Submissions Report

State Significant Development (SSD-69773460)

Mixed Use Development

35-37 Dwyer Street and 372-374 Mann Street, North Gosford

Figure 2 Comparison of Original and Amended On-Structure Landscaping Adjacent to Private Road/Driveway

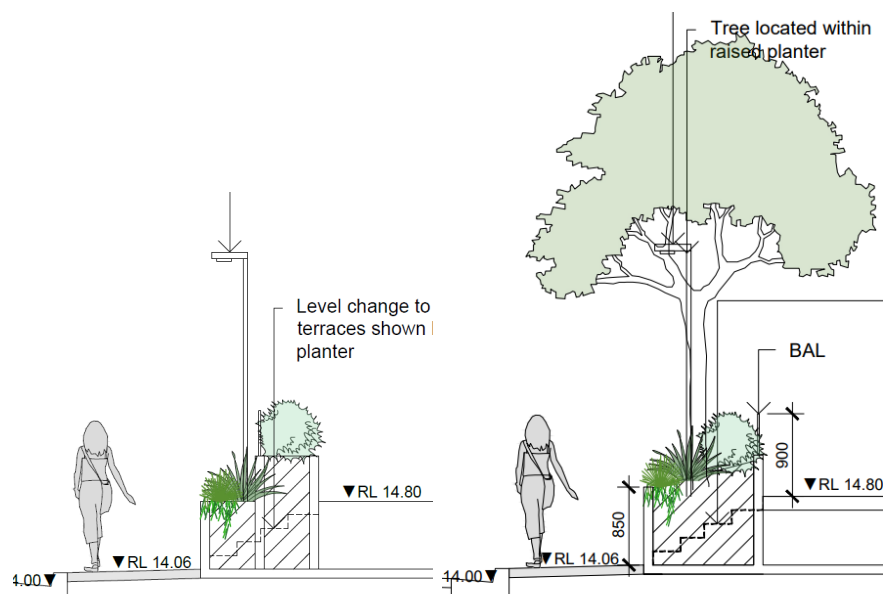
2.3	City of Gosford Design Advisory Panel The Department notes that deep soil and tree canopy arrangements adjoining the private road provide inadequate amenity, the basement extent limits deep soil and mature plantings, the trees are positioned too close to the fence line of ground-floor dwellings, restricting growth, reducing traffic buffering, and resulting in insufficient footpath width. To address this, it is recommended that consideration is given to: • Reconfiguring the basement to allow deep soil for mature street trees. • Relocating street trees to the kerbside of the pedestrian way. • Demonstrating adequate space for trees and pedestrians consistent with Council's Street Guidelines.	Council has confirmed that the private road/driveway is not sought as a public road. Accordingly, the treatment of this edge of the development is akin a side boundary. The proposed development provides deep soil in accordance with the DCP and ADG. Nonetheless, the landscape plans have been amended to improve soil volume by adjusting the location of the fence line and by removing a internal retaining wall increasing opportunity for meaningful canopy establishment along the western edge of development. Refer to Figure 2 above and Figure 11 below.	Attachment D

The ground floor terrace on-structure landscaping adjacent to the proposed private road/driveway has been amended to increase soil volume for tree planting by removing a dividing planter box wall and stepping in the palisade front fence. **Figure 2** provides a section of the original and amended planting area. Amended landscape plans are provided at **Attachment D**.

Figure 3 Sun Shading – Podium B2 and B3

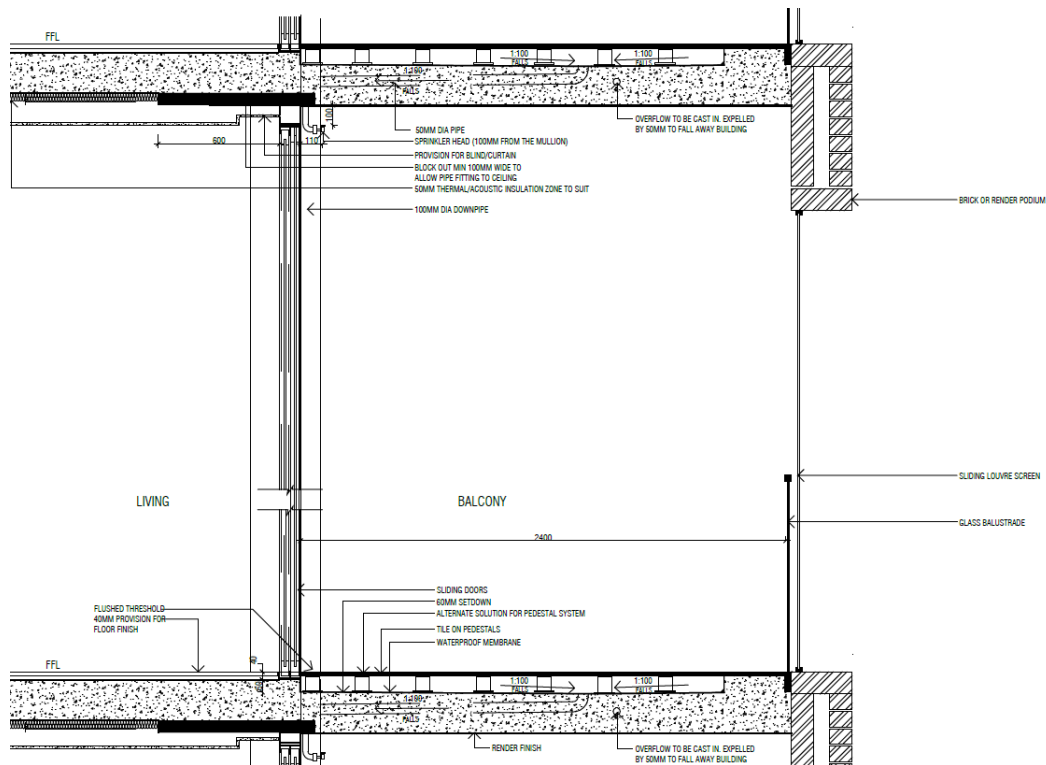
1.2	City of Gosford Design Advisory Panel Detailed sun-shading to the east and west elevations of buildings B2 and B3 and consider additional sun-shading for the western elevation of the tower, noting the proposed shading provides limited coverage and benefit.	Additional sun-shading is detailed in a new architectural drawing No. DA 602 for Building B2 and B3. The lower podium is shaded by a 500mm brick/render edge. Both the lower and upper podium are provided a sliding louvre screen. Additional detail is provided in relation to Building B1 shading as shown on amended drawing Nos. DA-600.	Attachment B

Amended sectional detail is provided for Buildings B2 and B3 in relation to sun-shading. An excerpt of new architectural drawing no. DA-602 is provided in **Figure 3. Section 4.2** provides a written response to the matters raised.

Figure 6 Original (Left) and Amended (Right) Civil Engineering Drawings

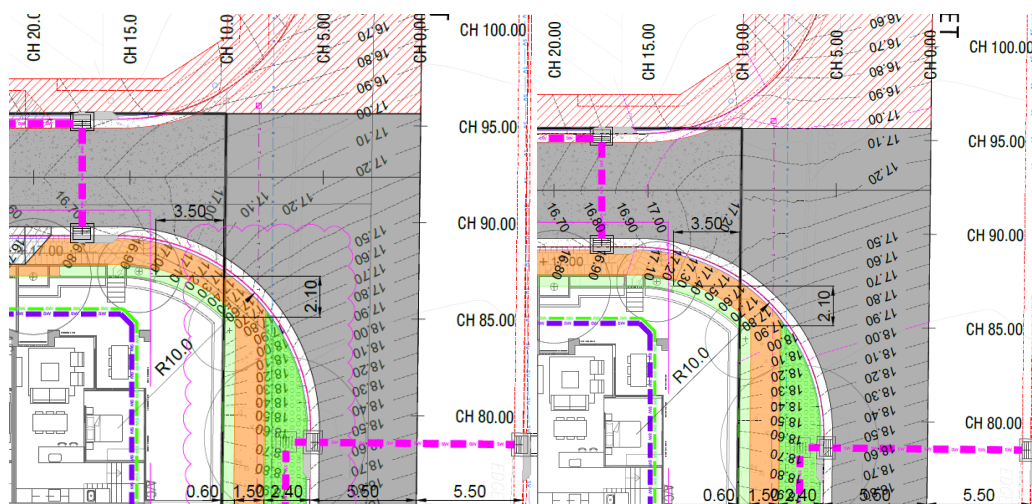
Ref.	Summary of Submission Topic	Response	Reference
7.1	Central Coast Council has requested the following amendment to road drainage: 'The design of the intersection of Dwyer Street and the new Private road as indicated on the Civil Engineering Plans prepared by Smart Structures (Appendix V) indicates that the private road grades away from Dwyer Street resulting in bypass flows from the kerb inlet pit entering the site via the Private Road. The design is to be modified to ensure that the private road grades towards the kerb line in Dwyer Street to ensure that stormwater flows from Dwyer Street do not enter the site via the Private Road. These amendments also have the potential to alter the levels on the Architectural plans in the vicinity of the Private Road and connectivity to the footpath levels adjacent to the private road as well.'	The driveway design has been raised approximately 200mm to prevent stormwater flows from entering the site via the private road, the stormwater is redirected to the kerb in Dwyer Street (see Section 3.2.7 of this Submissions Report).	Attachment G Attachment H

The amended civil engineering drawings provide a crest in the private road/driveway to ensure surface water from Dwyer Street does not enter the site. **Figure 6** provides an excerpt of the original and amended civil engineering drawings to demonstrate the introduction of the crest.

Figure 7 Original (Left) and Amended (Right) Loading Area – Building B1

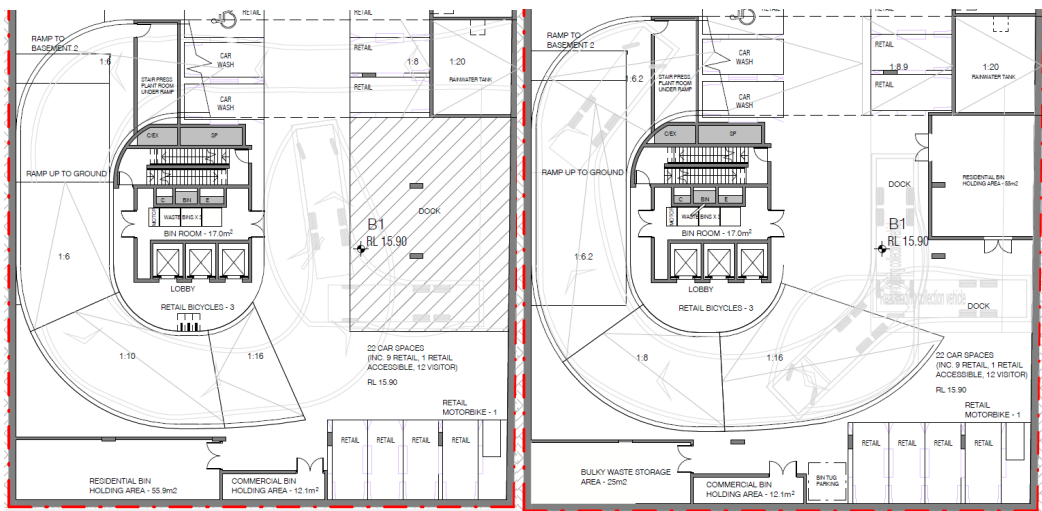
Ref.	Summary of Submission Topic	Response	Reference
10.1	Department of Planning, Housing and Infrastructure • Please review the proposed operational waste management and collection arrangements and provide further information on:	An amended waste management plan has been prepared (Attachment I) which includes the following response to submissions:	Attachment B Attachment F Attachment I

A comparison of the original and amended loading area within Building B1 and Building B2 is provided in **Figure 7** and **Figure 8** respectively.

Figure 9 Amended Swept Paths

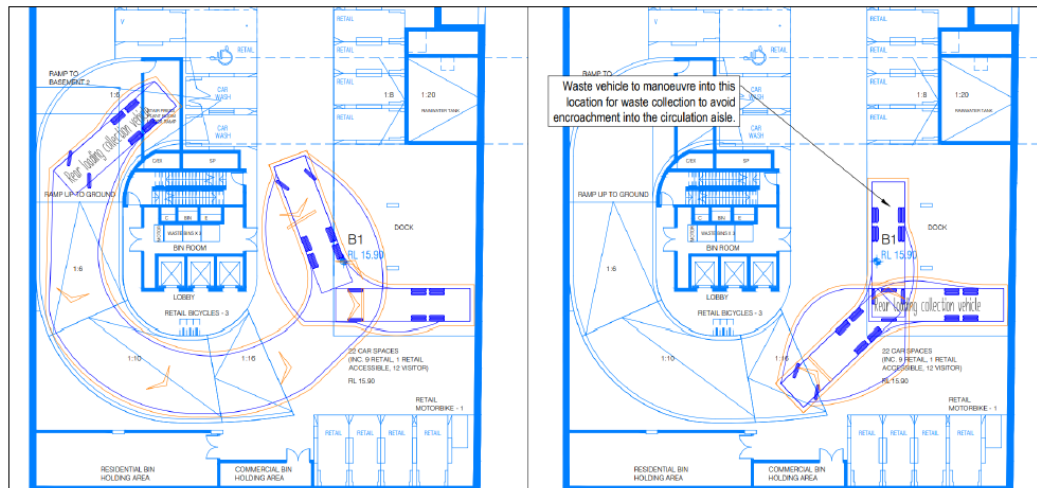
Ref.	Summary of Submission Topic	Response	Reference
T	Central Coast Council raised concern with the Waste Management Plan: - The supplied WMP indicates that “All residential waste and recycling services to the development will take place from a loading bay located in Basement 1 as indicated on the Architectural Drawings” however the plans indicate 2 loading docks. - The supplied WMP chapter 5.2.17 Assumptions: “A licensed private waste and recycling contractor will be provided all residential waste and recycling services to the development.” contradicts point 5.2.14 “The Central Coast Council will provide all residential waste and recycling services to the development.” this needs to be clarified and corrected – it should be noted that Council does not support private contractors to collect residential waste. - The proposal for a once weekly collection is not efficient given the proposed number of bins; Council can provide more frequent servicing for larger Multi Unit Dwellings, this will reduce the overall number of bins required by the development and provide a more efficient collection arrangement. - Council’s Resource and Waste Management Guidelines should be used to help determine the amount of waste, recycle and FOGO material likely to be generated, information on how much FOGO material and the number of bins, collection frequency is to be included in any Resource and Waste Management Plan. - Council requires that applicant use the correct forms within the Guidelines to ensure continuity and consistency in applying the intentions of the guidelines across a diverse range of development applications and associated activities. The forms provided support to applicants and ensure that all applications address the Council requirements in a uniform manner.	The number of FOGO bins is 10 x 240-litre based on fortnightly collection. The waste and recycling services for the residential component of the development will be provided by Central Coast Council. The amended plans do not reduce the number of bins and maintain once weekly collection as the proposed frequency. Any negotiation in relation to increasing collection frequency can occur between the future owners corporation and Council. The amended waste management plan is suitable for Council and DPHI to assess waste servicing of the development.	Attachment I

Waste vehicle manoeuvring to the loading area within Building B1 has been updated to remove the requirement to stand in the aisle during collection as shown in the amended swept paths within the Addendum Transport Letter (**Attachment F**) as shown in **Figure 9**.

Figure 10 Indicative Sewer Realignment

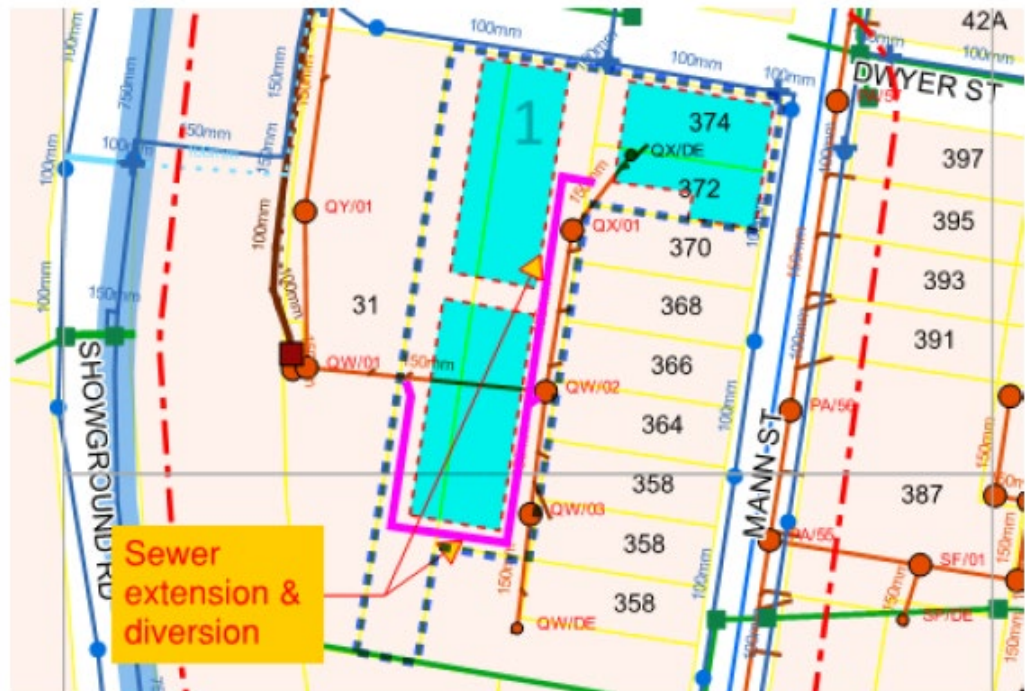
13.3	Central Coast Council has provided the following comment in relation to sewer requirements: 'There is an existing Council gravity sewer main traversing the development site. As per Council Building in Proximity to Sewer Pipeline Policy, Council will not support any sewer main to be located within the proposed underground car parking area. Any structure proposed in close proximity to Council sewer main shall be designed in accordance with Council policy. Sewer relining is required from the proposed development.'	The proposed development will augment the existing 150mm sewer line to a 225mm sewer line to the requirements of Central Coast Council. The new 225mm sewer line is designed to divert around the development. The connection to the existing downstream line will require further investigation to determine the size of the pipes.	Attachment J

An Amended Services Report has been prepared (**Attachment J**) to provide an additional diagram showing an indicative sewer re-routing around the basement of Building B2/B3 as shown in **Figure 10**.
